**CITY OF SACRAMENTO PLANNING COMMISSION**  
**1231 "I" STREET, SUITE 200, SACRAMENTO, CA 95814**

**PROPOSAL:** The applicant is requesting the necessary entitlements to merge two parcels into one and construct three single family homes.

APPLIC. NO. P91-078

MEETING DATE August 22, 1991

PLOT PLAN 1/16" = 1'-0"

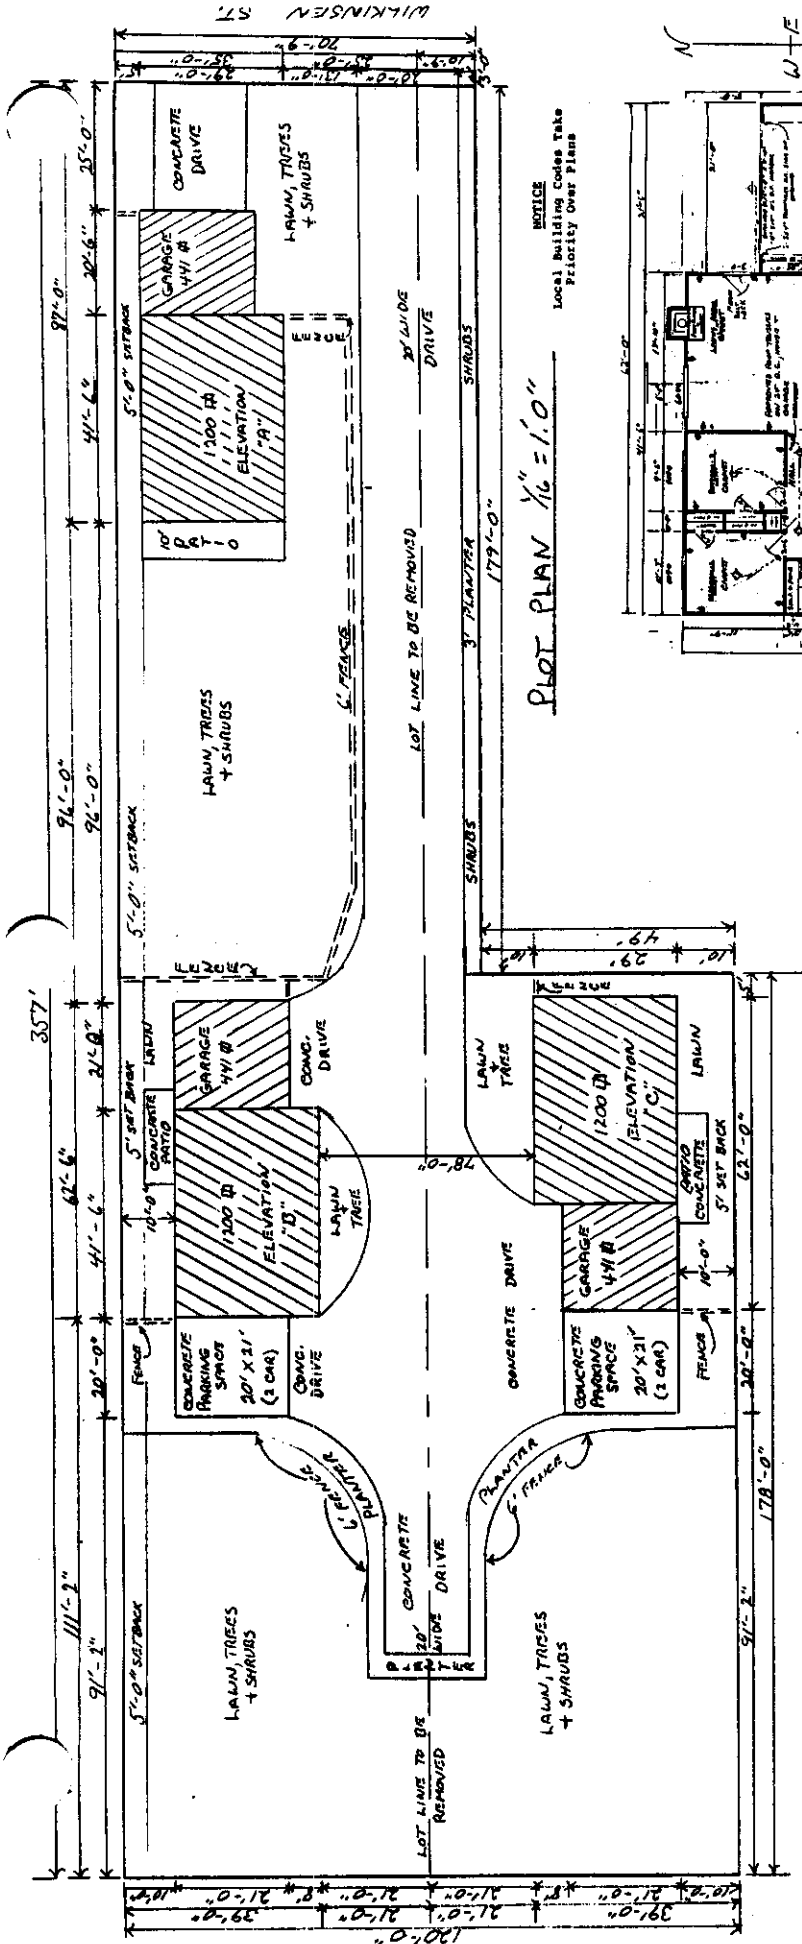
The site plan is designed such that there is a 20 foot driveway to the south of the front unit, with a three foot planter between the south property line and the driveway. The site plan indicates this planter to contain shrubs. The site plan also indicates lawn, trees, and shrubs for the other open areas on the parcel. All the landscaped areas should contain an automatic irrigation system. Staff suggests a detailed landscape and irrigation plan be submitted for Planning Director review and approval prior to the issuance of Building Permits.

The submitted site plan indicates fencing of yards for each unit. Staff suggests that wherever a fence is adjacent to the driveways, a minimum five foot planter be provided. Staff also suggests the rear 90± feet (to the west) be incorporated into the yards for Unit B and Unit C. It appears that this area is proposed to be fenced and inaccessible.

The plans indicate a two-car garage is provided for each unit. There is also a two-space concrete parking pad adjacent to Unit B and one adjacent to Unit C for guest parking. These parking areas, as well as the common driveway, are required to meet the 50 percent shade requirements of the Zoning Ordinance.

1. The large radius curves at the driveways waste potential green area and are not required for maneuvering.
2. The applicant shall complete the following at the Public Works Department, Development Services Division, prior to a lot line adjustment/merger being recorded:
  - a. File a Certificate of Compliance, submit all required documents according to the submittal requirements checklist, and pay necessary fees.
  - b. File a waiver of Parcel Map.
  - c. Pay off or segregate any existing assessments.
  - d. Coordinate with County Sanitation District.
  - e. Notice: Property to be adjusted/merged in accordance with this certificate of compliance may

A fire hydrant is required within 300 vehicular feet of each structure. None is indicated on the plans.

As a council, we do not like these deep lot projects, but that is not new. We suggest you require the two rear structures to be offset from each other to reduce the "staring at each other" syndrome. For example, change "B" to another "A" style and move to the extreme west end of the parcel. Also, rear fencing on "B" and "C" does not make any sense.

1. Staff a detailed landscape and irrigation plan shall be submitted for Planning Director review and approval prior to the issuance of Building Permits. All landscaped areas shall contain an automatic irrigation system.

2. Wherever a fence is adjacent to the driveways, a minimum five foot landscaped planter shall be provided.
3. The sideyard fencing shown on Units B and C which eliminates access to the rear 90± feet of the parcel shall be moved such that the area is incorporated into the yards for Unit B and Unit C.

4. The parking areas, as well as the common driveway, shall meet the 50 percent shade requirements of the Zoning Ordinance.
5. The applicant shall submit revised elevations for review and approval of the Planning Director prior to the issuance of Building Permits. The revised elevations shall include the following:

ELEVATION "B" (NOT TO SCALE)

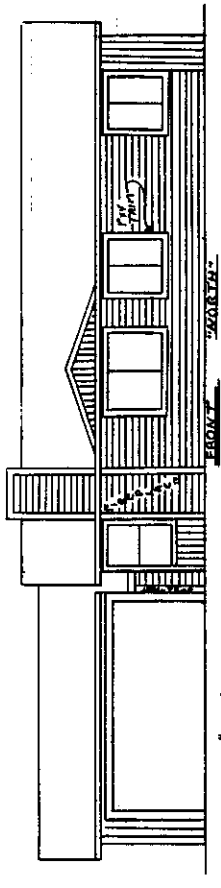
**Elevation B** - The north and east elevations should consist of the horizontal lap siding. The accent trim is shown as T1-11 siding. The trim should be brick as shown on Elevation C. All vents should be boxed and accented with wood trim. The front door should be six panel of either metal or wood. The garage door should be a metal sectional with a raised panel design. The roof material should consist of a 25 year laminated dimensional composition shingle.

- a. Each unit shall have a front door which is six panel of either metal or wood. The garage door shall be a metal sectional with a raised panel design, and the roof material shall consist of a

25 year laminated dimensional composition shingles. All vents shall be boxed and accented with wood trim.

ELEVATION "C" (NOT TO SCALE)

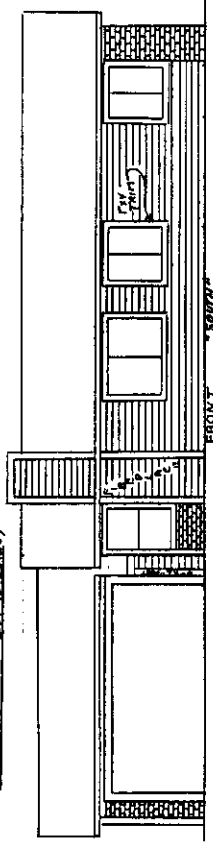
**Elevation C** - The south and east elevations should consist of the horizontal lap siding. The trim shall be brick as indicated on the submitted plans. All vents should be boxed and accented with wood trim. The front door should be six panel of either metal or wood. The garage door should be a metal sectional with a raised panel design. The roof material should consist of a 25 year laminated dimensional composition shingle.

FRONT ELEVATION "A" (NOT TO SCALE)

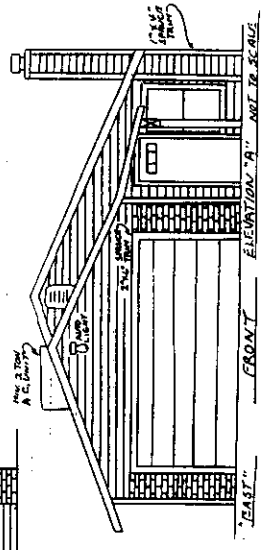
**Elevation A** - The south and east elevations should consist of horizontal lap siding as indicated on the submitted plans. The trim should be brick as indicated on the submitted plans. There should be gridded windows in the front facing Wilkinson Street. There should be a false vent on the garage which is boxed out and accented with trim. The front door should be six panel of either metal or wood. The garage door should be a metal sectional with a raised panel design. The roof material should consist of a 25 year laminated dimensional composition shingle.

- b. On Elevation A the south and east elevations shall consist of horizontal lap siding as indicated on the submitted plans. The trim shall be brick also as indicated on the submitted plans. There shall be gridded windows in the front facing Wilkinson Street. There shall also be a false vent on the garage which is boxed out and accented with trim.
  - c. On Elevation B the north and east elevations shall consist of horizontal lap siding. The trim shall be brick as shown on Elevation C.
  - d. On Elevation C the south and east elevations shall consist of horizontal lap siding. The trim shall be brick as indicated on the submitted plans.
6. A fire hydrant is required within 300 vehicular feet of each structure.
